Nebraska Public Power District

NLS2014001
January 17, 2014

- Subject:** 60-Day Response to Request For Additional Information Regarding License Amendment Request To Adopt National Fire Protection Association Standard 805 Cooper Nuclear Station, Docket No. 50-298, DPR-46

60-Day Response to Cooper Nuclear Station
Request For Additional Information Regarding
License Amendment Request To Adopt
National Fire Protection Association Standard 805

Table 1: Main Control Room Abandonment Human Failure Events

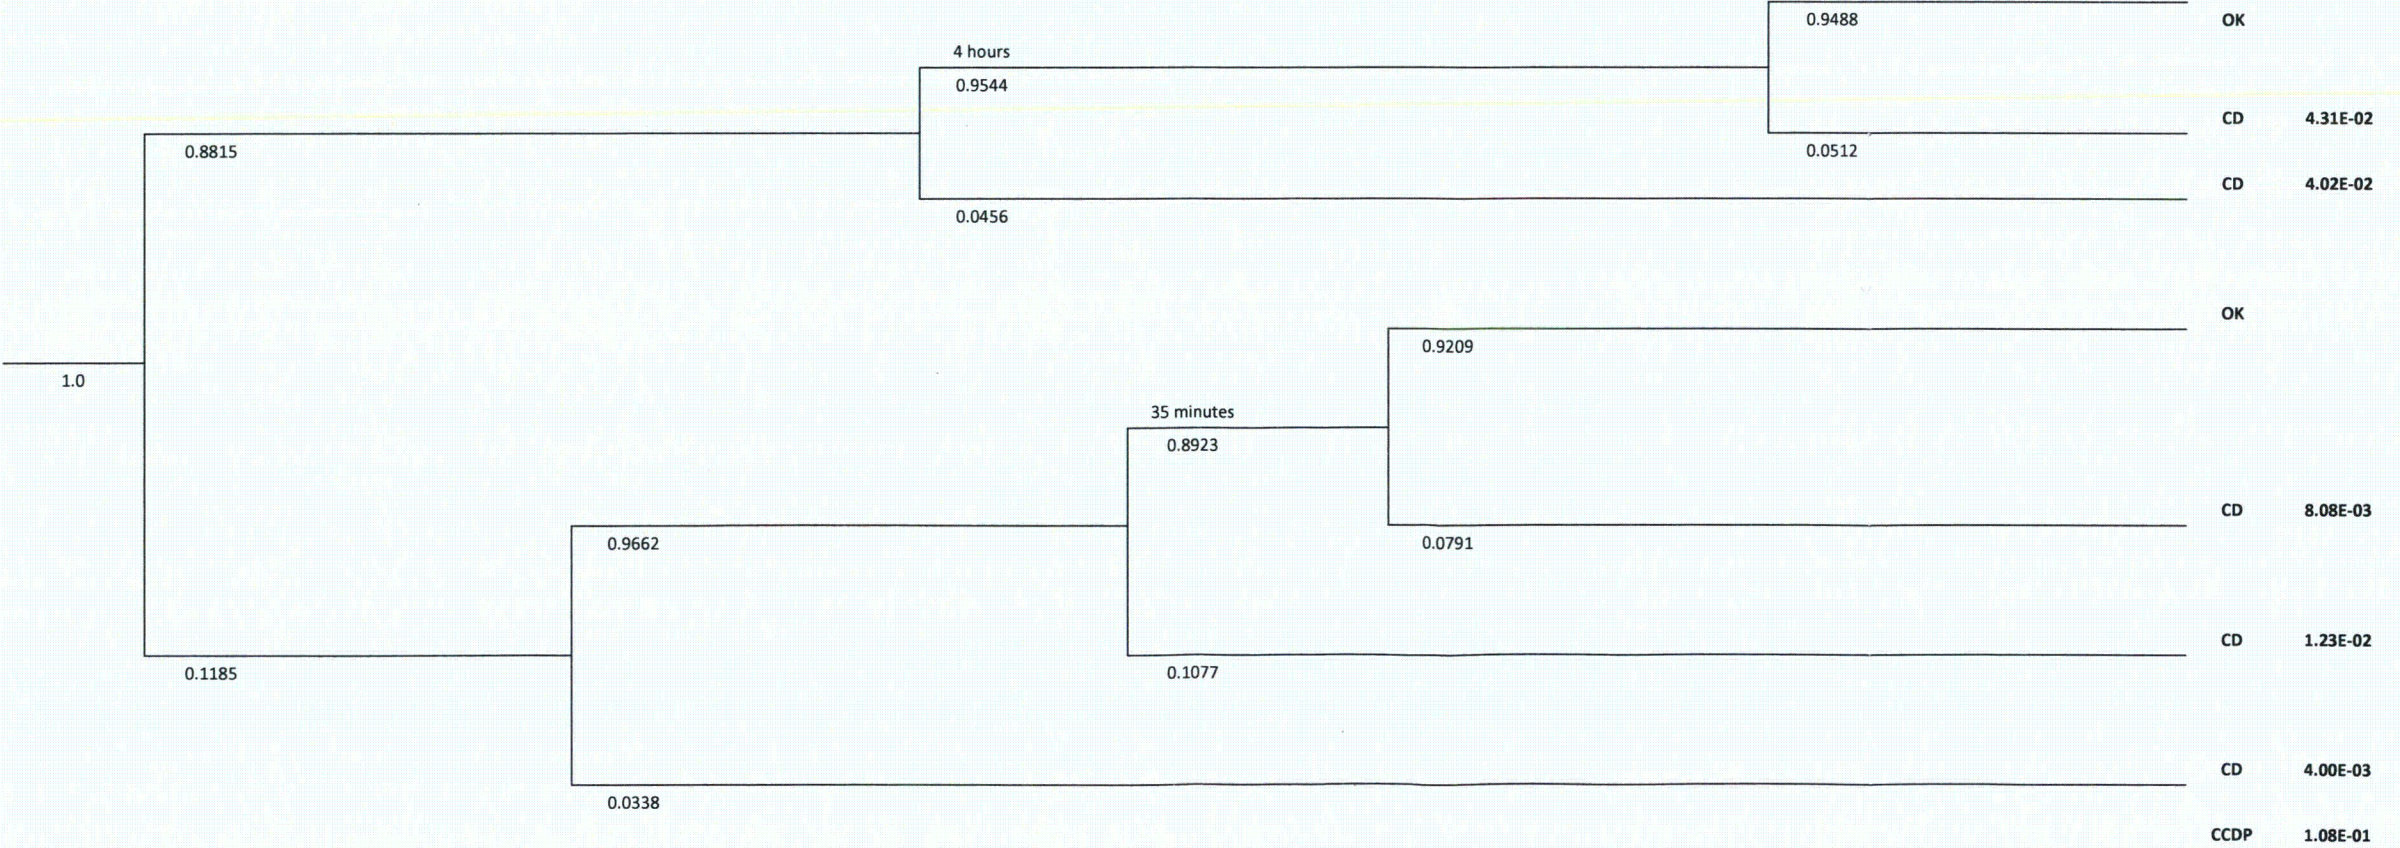
- a. *Describe whether there are any values other than 0.1 used to characterize the HEP following MCR abandonment and whether the 0.1 also represents the CCDP. In addition, describe the CLERP.*

- b. If any values other than 0.1 are used, (e.g., 1.0), provide the other values, a characterization of the scenarios where these values are used, and a summary of how each value is developed. This information should include explanations of how the following scenarios are addressed.*

- a. In the analysis for the LAR submittal, only the value of 0.1 was used for MCR abandonment fire scenarios. The MCR abandonment CCDP/CLERP of 0.1 was characterized by incorporating both the HEP for shutdown from outside the MCR and system/train failures into the CCDP/CLERP. The MCR abandonment value for CLERP was taken to be equal to the MCR abandonment value for CCDP.
- b. In response to this RAI, the MCR abandonment analysis was revisited. The re-analysis for MCR abandonment addresses human and equipment performance in lieu of the screening approach presented in the LAR. The same procedure is used for all fires leading to MCR abandonment; whether abandonment was due to loss of command and control or loss of MCR habitability. The re-analysis identified actions at the primary control station (PCS), local actions (actions away from the PCS), and equipment reliability/availability.

The ASD procedure uses Reactor Pressure Vessel (RPV) injection with High Pressure Coolant Injection (HPCI) as the preferred safe shutdown path with Residual Heat Removal (RHR) pump D in Suppression Pool Cooling (SPC). Should HPCI injection fail, RHR pump D is available for Low Pressure Coolant Injection (LPCI) injection providing the RPV is depressurized. A MCR abandonment tree was developed for ASD as shown in Figure 1 below.

The ASD HEPs for all actions, both at the PCS and away from the PCS, were developed using the Human Reliability Analysis (HRA) Calculator and the methods in NUREG-1921. HEPs for MCR abandonment scenario actions are provided in Table 1 below. Equipment reliability/availability was determined for ASD systems and is provided in Table 2 below. The incorporation of ASD human actions and equipment performance into the model resulted in a MCR abandonment CCDP of approximately 0.108 as shown in the MCR abandonment tree (Figure 1). MCR abandonment CLERP was again taken to be the same as CCDP.
